US 29 Bus Rapid Transit (BRT) Corridor Planning Study Briefing

Summary

This is primarily a briefing. The purpose is to provide the Planning Board with an opportunity to review the staff comments on the Draft Corridor Study Report and receive an update on the status of BRT planning in the US 29 corridor. The Planning Board will be asked to approve forwarding the staff comments with revisions as necessary. In addition, MTA and MCDOT staff will review the scope of the next phase of work related to the introduction of BRT in the corridor. **Emphasis will be placed on the recent decision by MTA and MCDOT that more analysis is required to reach a recommendation on how or whether to include managed lanes as part of the longer term and given that, there is no plan to recommend a Locally Preferred Alternative from among those analyzed in this Study for advancing into preliminary engineering (30% design). The near-term focus instead will be on advancing the County Executive’s 2020 Plan.** The staff comments are noted in bold throughout the document and presented in summary format at the end of the staff report. It is this set of comments that the staff is requesting the Planning Board appr

Figure 1 – Alternative A

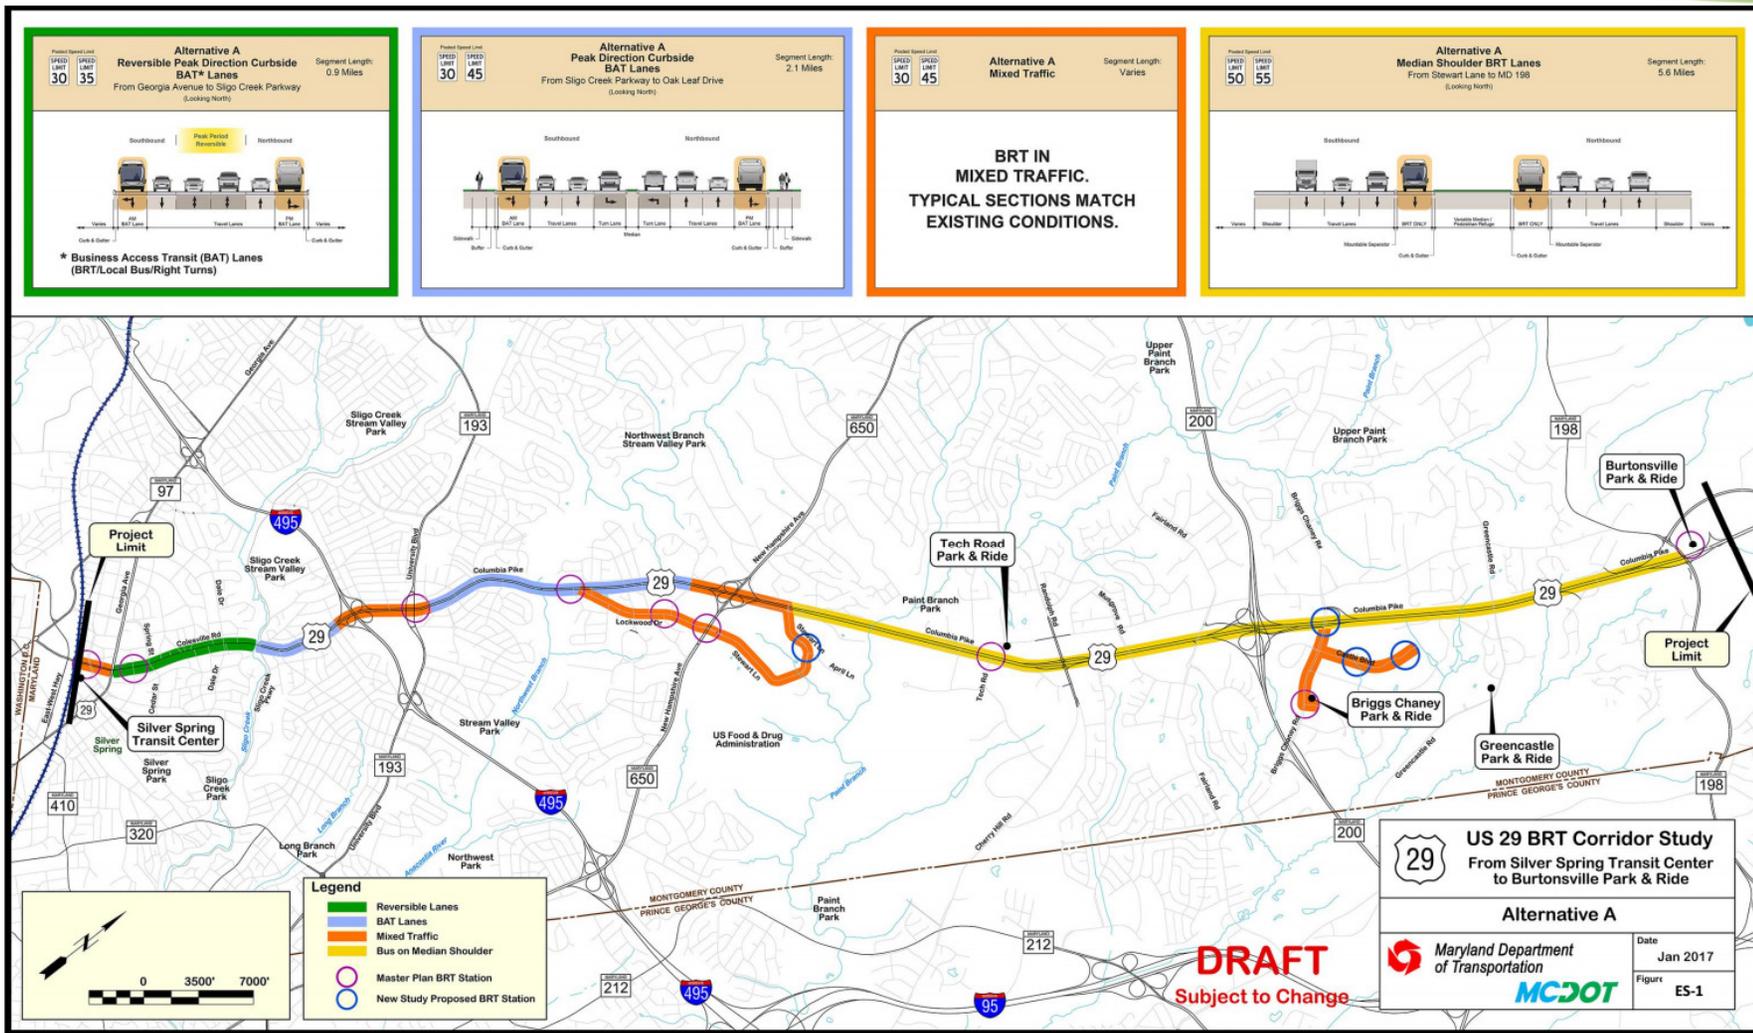
Alternative A and Alternative B Modified transition from the buses using center lanes in the north to outside or shoulder lanes in the south. Staff is concerned this transition will further slowdown buses in heavy traffic. Therefore, it may be helpful to describe this transition and what can be done to assist in the large merge required mid-way through the route.

Figure 3 – Alternative B Modified

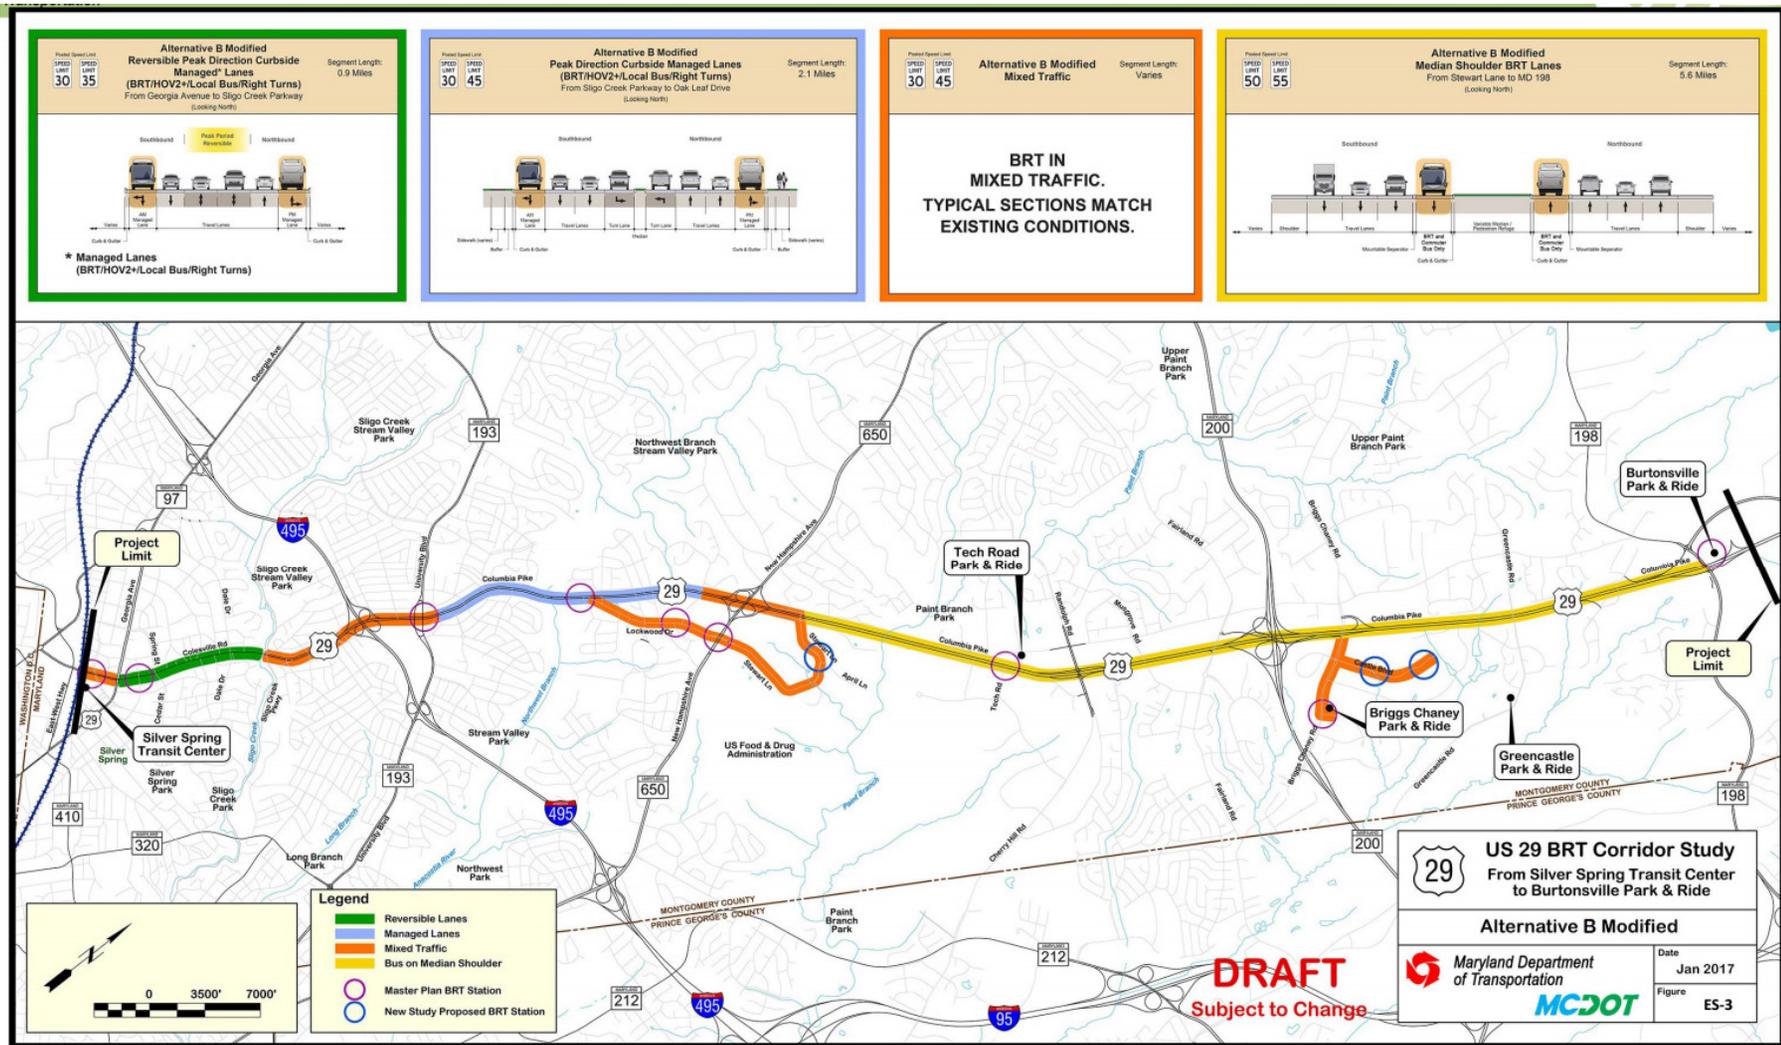
⁴ The section title and corridor depiction of peak direction curbside managed lanes (i.e., the blue segment) appear to be inconsistent with respect to where the treatment ends on the south end of the corridor.

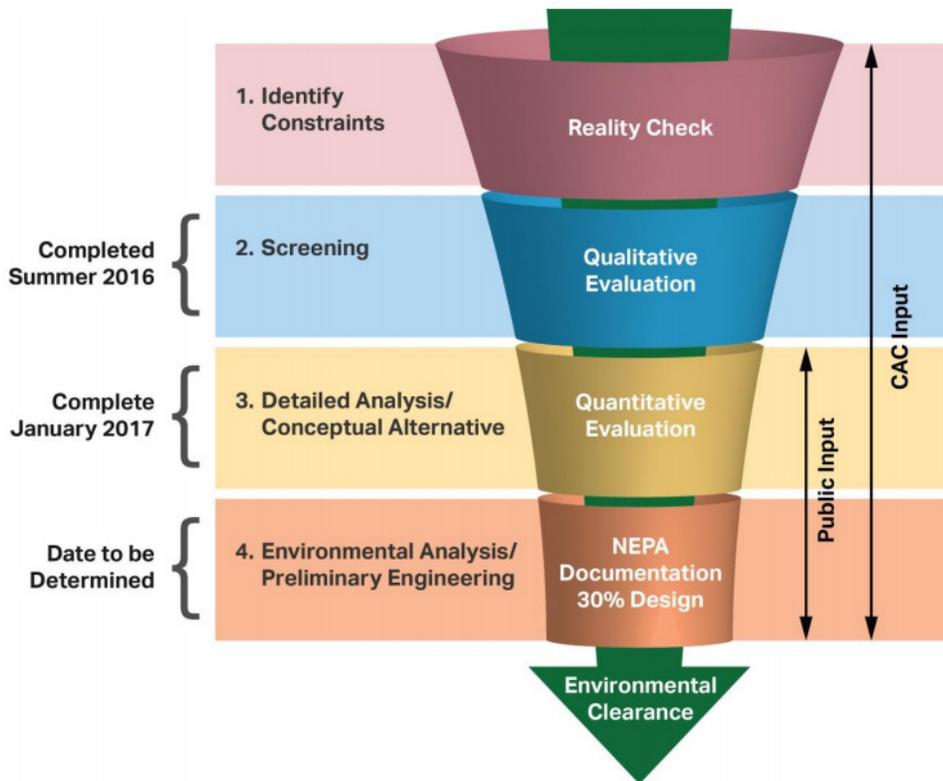
The Study includes the following process flow chart depicting the fourth step as now occurring on a date to be determined. Typically, at this point in the process, a Locally Preferred Alternative would be recommended to advance into the fourth step.⁷ In this case, the Study team has concluded that it cannot recommend an alternative because the implementation of managed lanes requires additional analysis. Managed lanes as defined in the Study are an element of both Alternative B and Alternative B Modified. Managed lanes are not an element of Alternative A. The Study (page 56) notes the slight difference between Managed Lanes and BAT lanes being that non-bus HOVs are restricted from the BAT lanes and must remain in the general-purpose traffic lanes.

The Study also does not include narrative on why managed lanes require additional analysis or why the additional analysis cannot be conducted now to better evaluate the alternatives before moving into the fourth step as shown in the chart above. This information should be included in the Final Study Report.
